APPLICATION NO: 13/00756/FUL		OFFICER: Mrs Wendy Hopkins
DATE REGISTERED: 10th May 2013		DATE OF EXPIRY : 9th August 2013
WARD: Leckhampton		PARISH: LECKH
APPLICANT:	Martin Scott Homes	
LOCATION:	Leckhampton Industrial Estate, Leckhampton Road, Cheltenham	
PROPOSAL:	Demolition of existing buildings and residential development comprising the construction of 28 dwellings

ADDITIONAL REPRESENTATIONS 11th – 13th November 2013

Demolition of existing buildings and residential development comprising the construction of 28 dwellings. Leckhampton Industrial Estate, Leckhampton Road, Cheltenham, Gloucestershire, GL53 0AL, by Martin Scott Homes (205 Leckhampton) Ltd.

ANALYSIS OF THE PROPOSED DEVELOPMENT AT 205 LECKHAMPTON

57 Collum End Rise Ground Floor

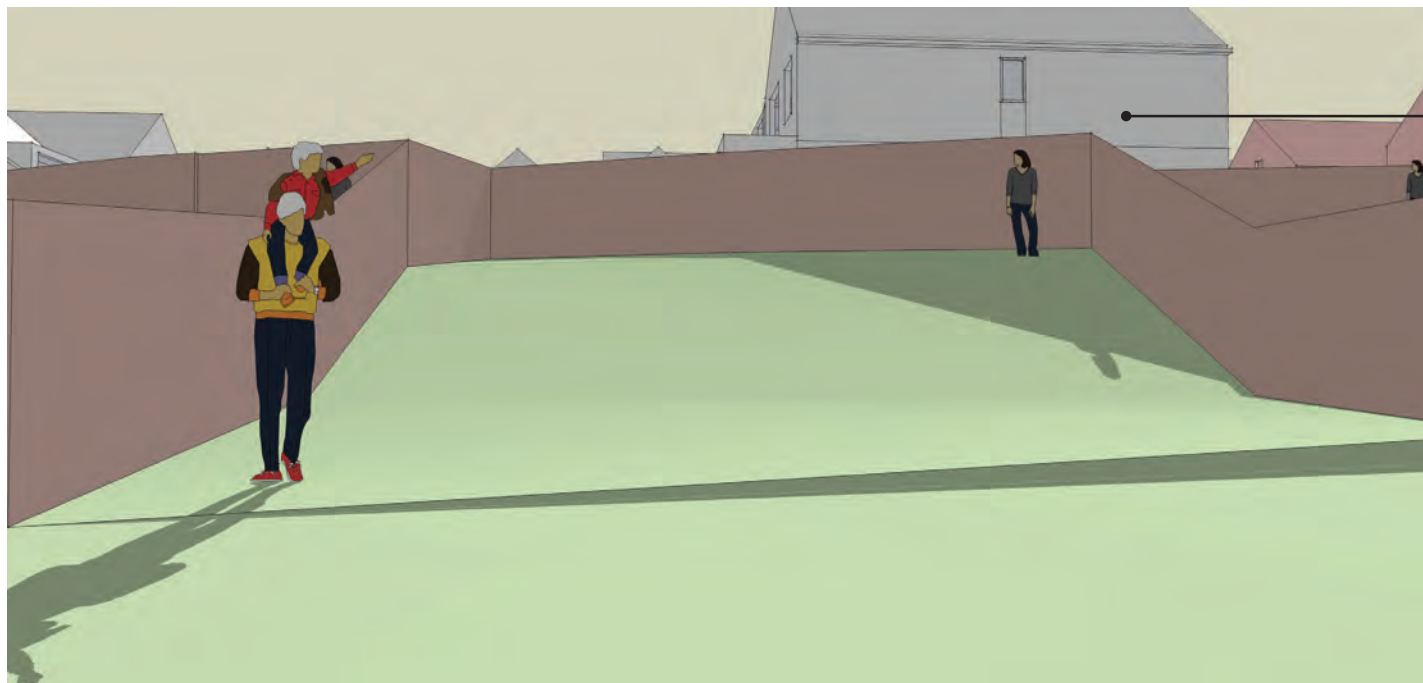
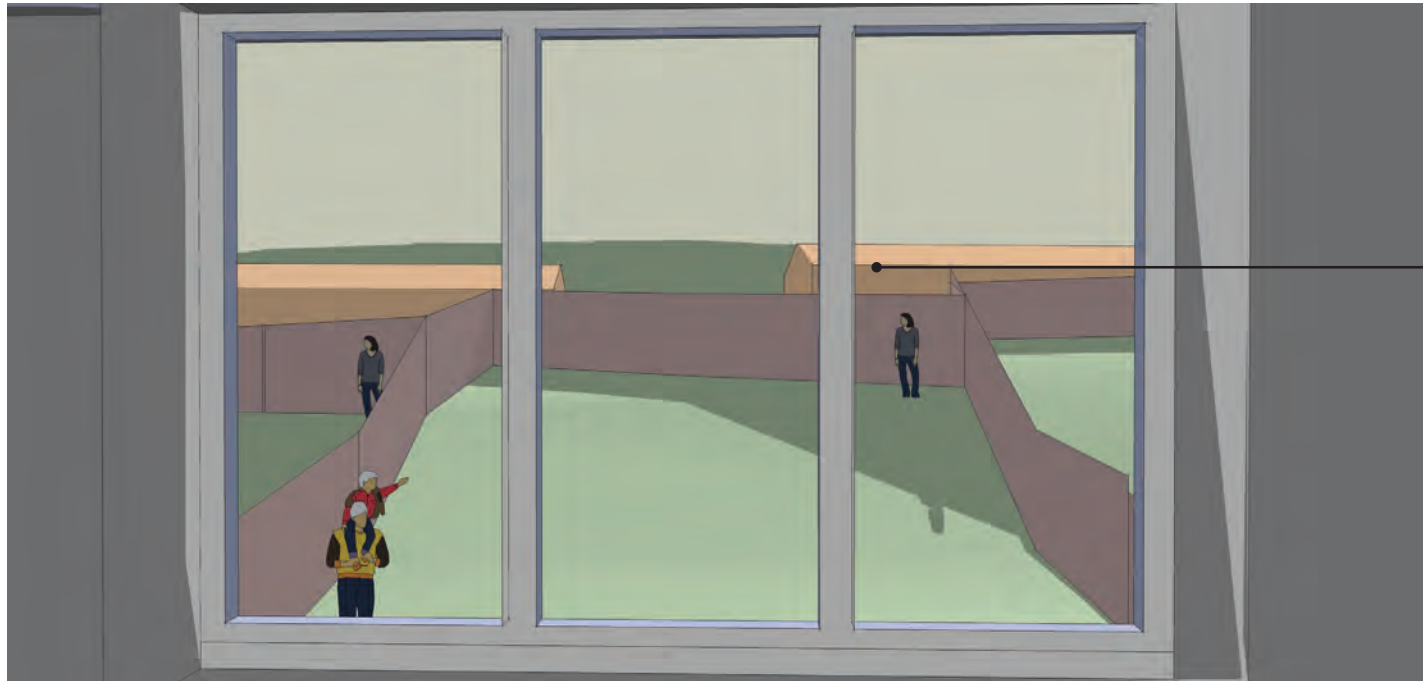
Over a storey of the proposed properties are visible over the proposed 1.8m high boundary fence.

With the proposed Ground Floor 4.23m above the patios a 5m high side elevation the effective height of the eaves is over 9m. This is equivalent to a 3 storey building to the eaves.

Proposed properties have a significant visual impact due to scale of the proposals and elevated site.

The Ground Floor of the proposed house (plot 18) is 4.23m above the existing patio level adding nearly two storey to the effective height.

61 Collum End Rise First Floor

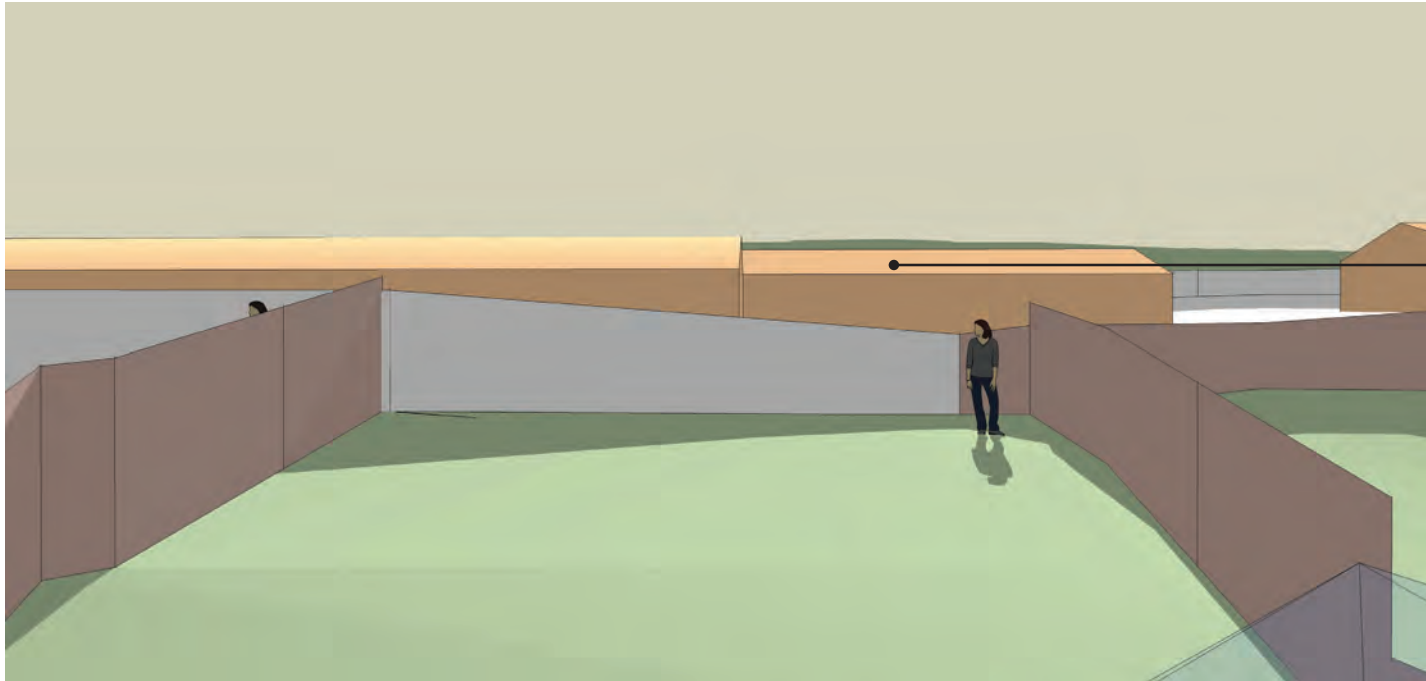
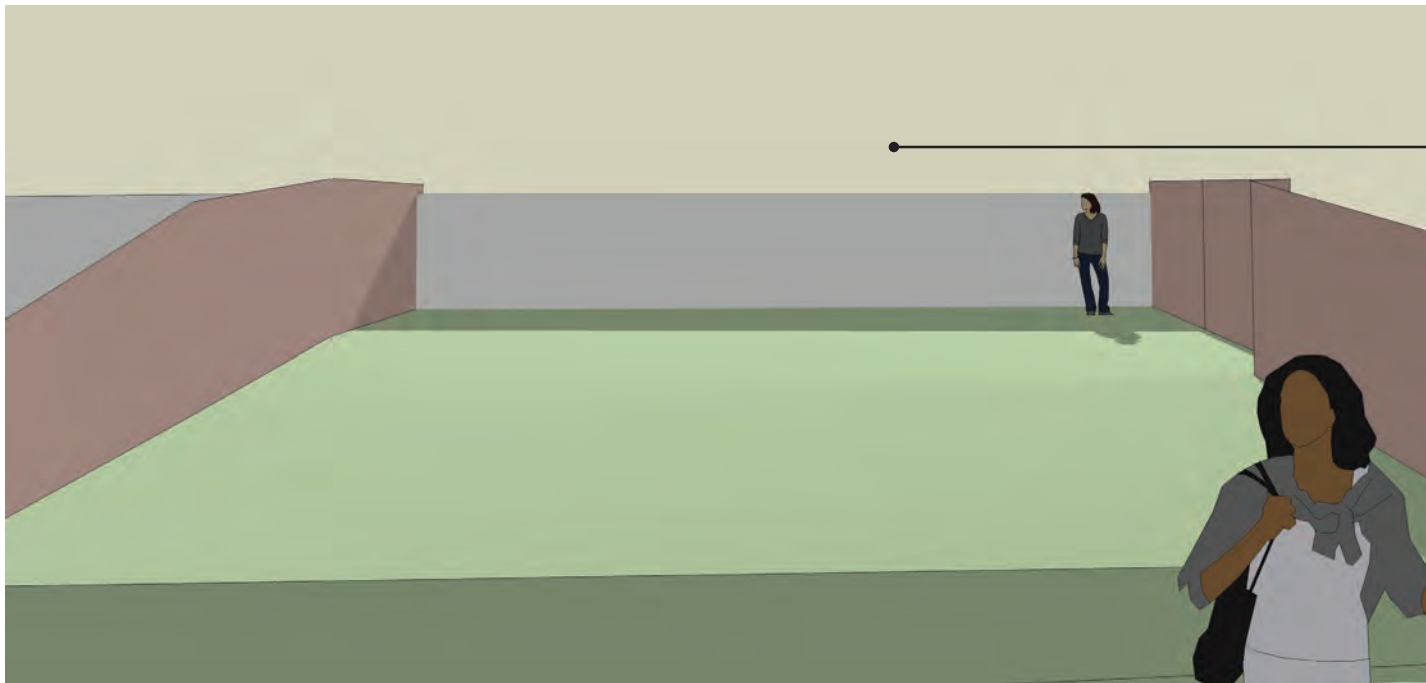
3 storey proposed properties have a significant visual presence either side of plot 23. Thin spaces/gaps between the proposed plots do not break up the facades due to oblique views.

Proposed properties have a significant visual impact due to scale of the proposals and elevated site. Reducing plot 23 to a single storey would have significantly reduce the impact.

63 Collum End Rise First Floor

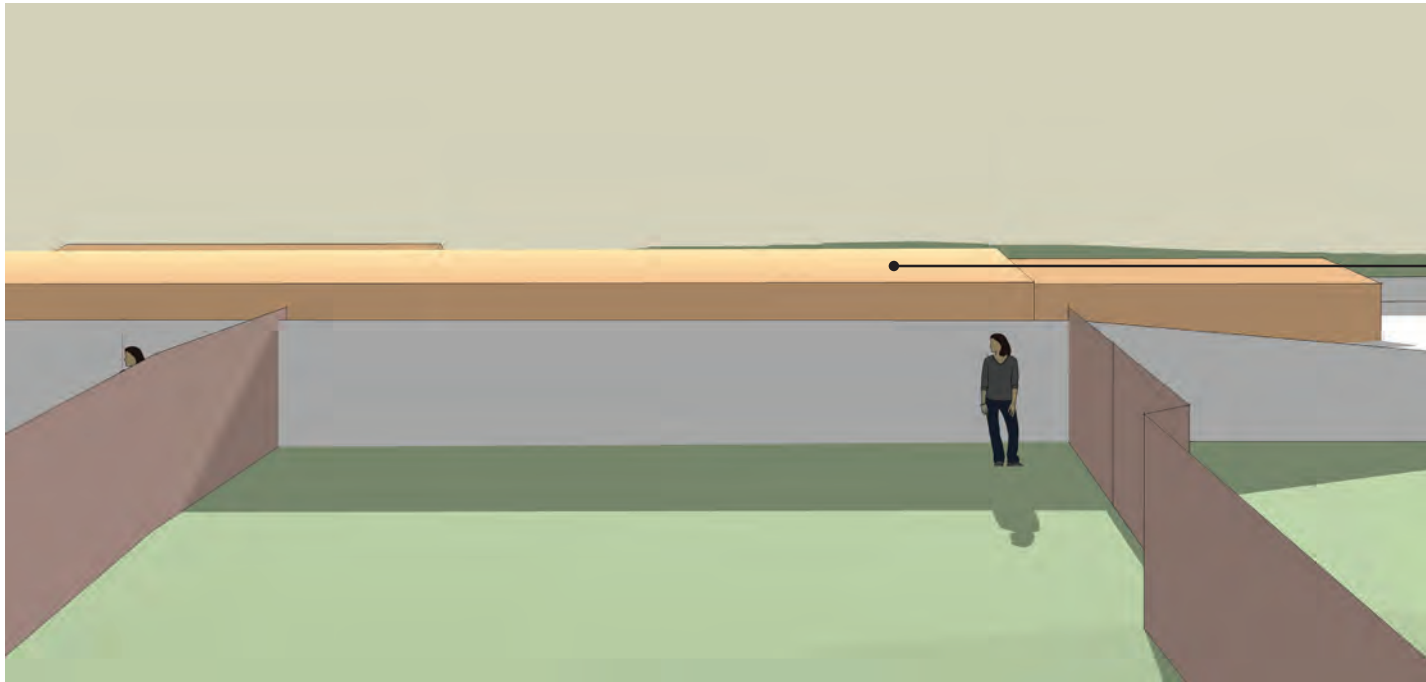
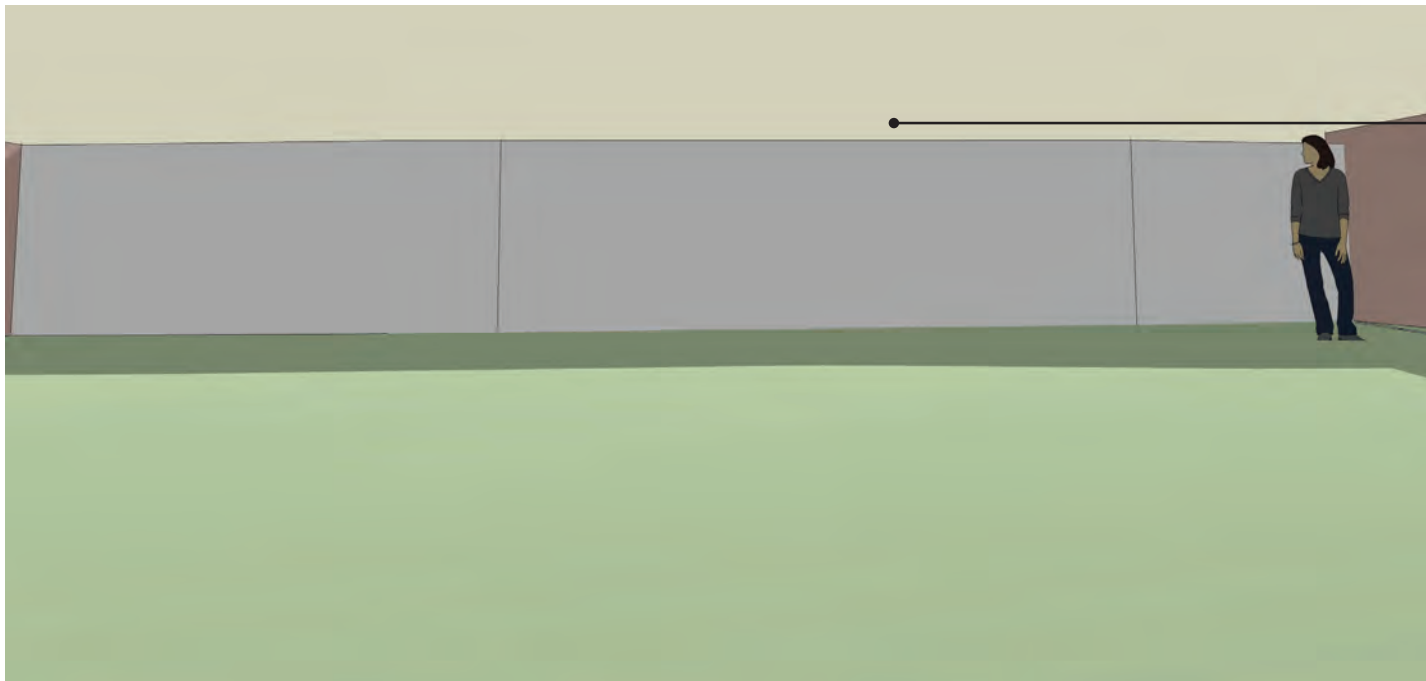
3 storey proposed properties visible through gaps in buildings adds to overall mass of the proposals

Proposed properties have a significant visual impact due to scale of the proposals, elevated site and proposed habitable rooms with views into existing bedrooms.

The Ground Floor of the proposed house (plot 24) is 2.77m above the existing patio level adding a storey to the effective height.

3 Liddington Road First Floor

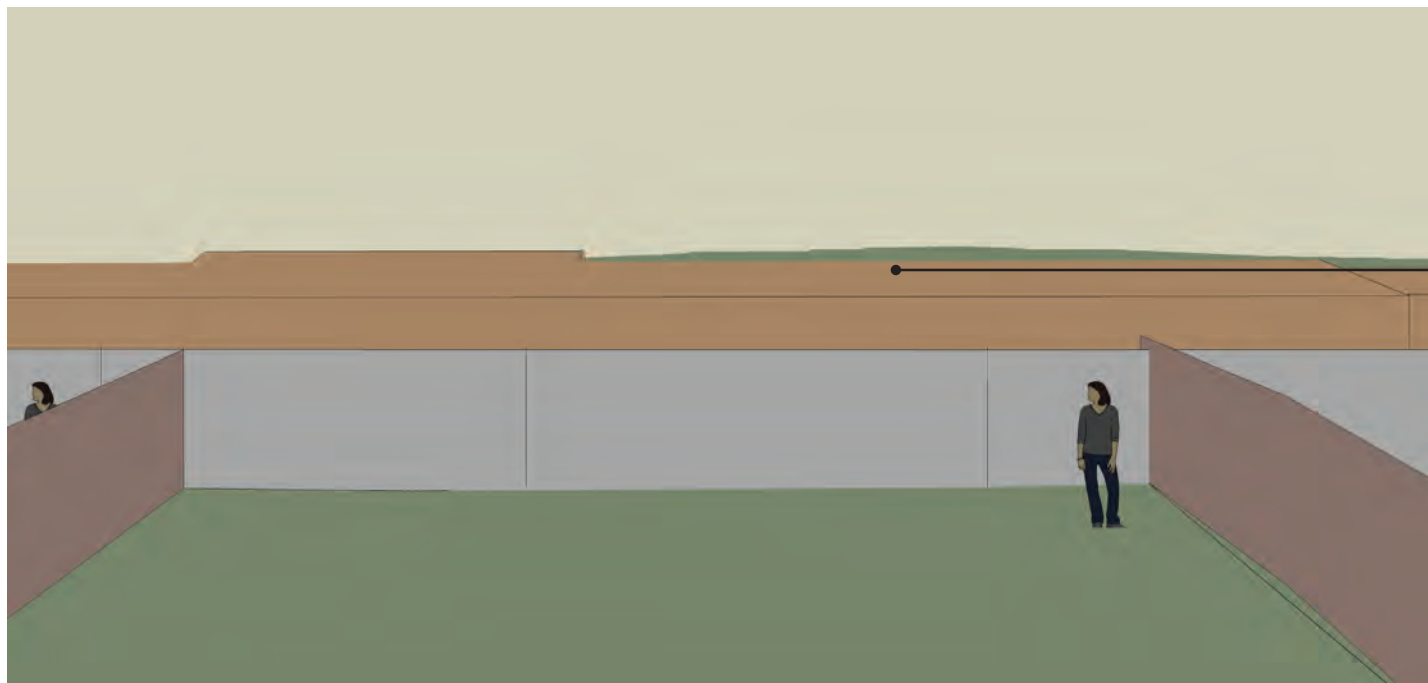
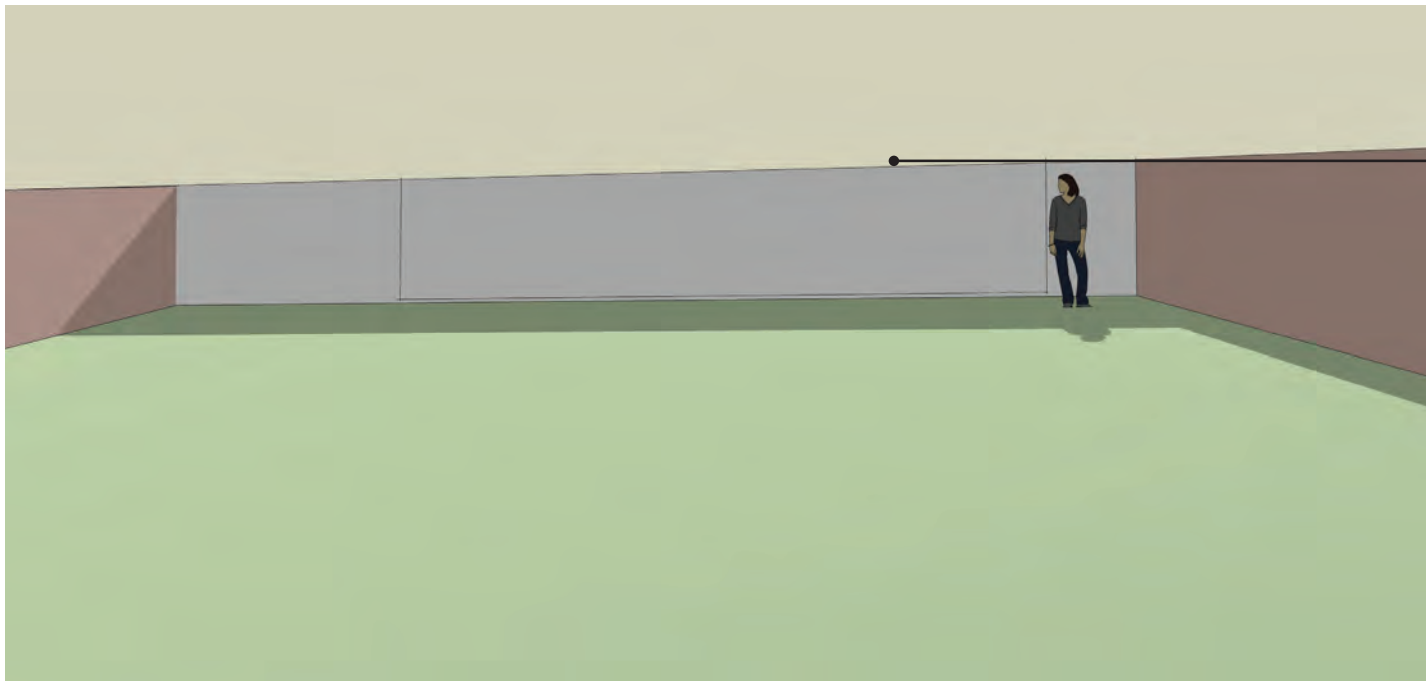
3 storey proposed properties visible through gaps in buildings adds to overall mass of the proposals

Proposed properties have a significant visual impact due to scale of the proposals, elevated site and proposed habitable rooms with views into existing bedrooms.

The Ground Floor of the proposed houses (plot 24) is 2.79m above the existing patio level adding a storey to the effective height.

1 Liddington Road First Floor

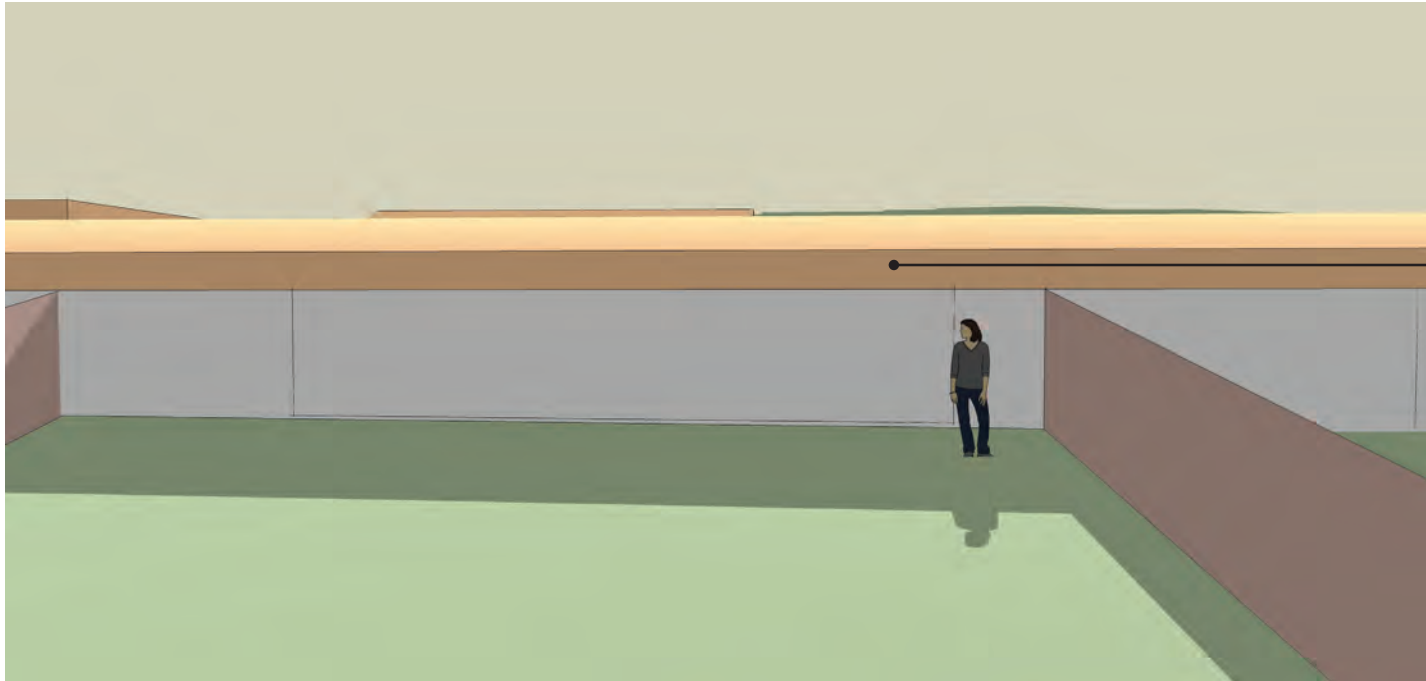
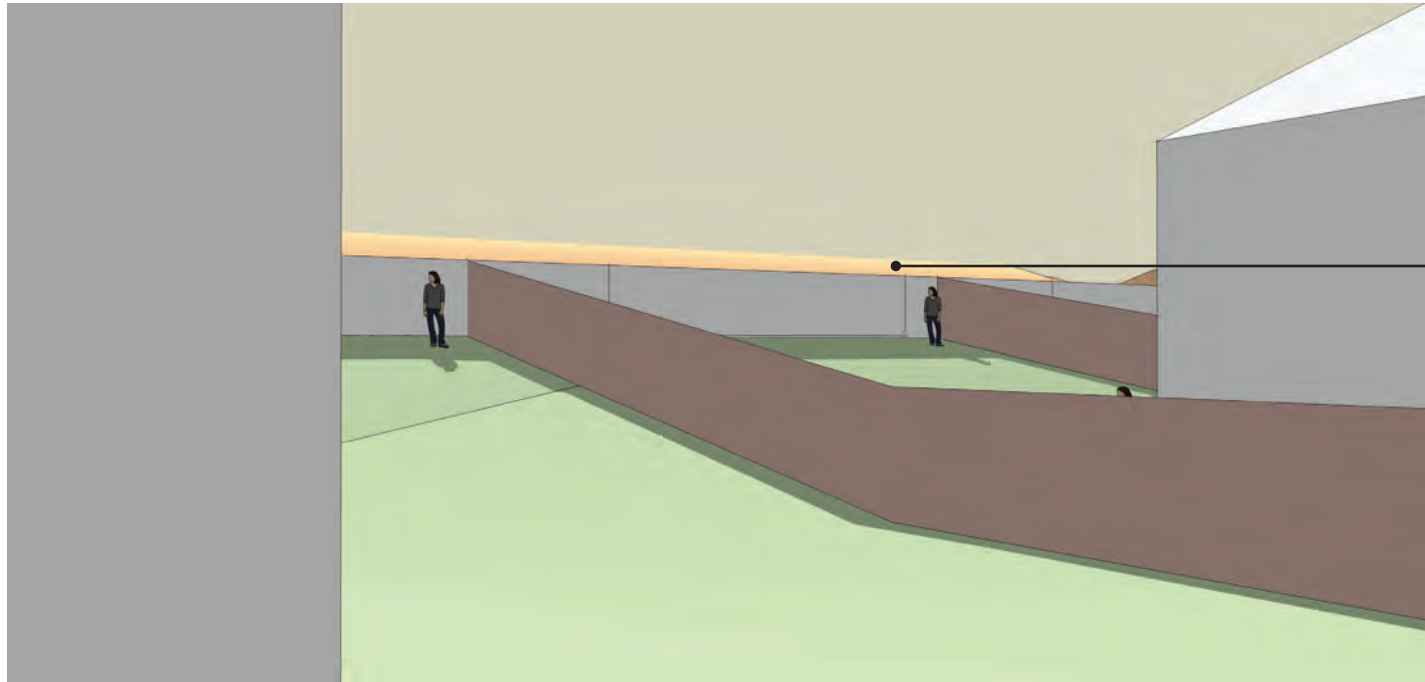
Proposed properties have a significant visual impact due to scale of the proposals, elevated site and proposed habitable rooms with views in to existing bedrooms.

The Ground Floor of the proposed houses (plot 26) is 2.34m above the existing patio level adding nearly a storey to the effective height.
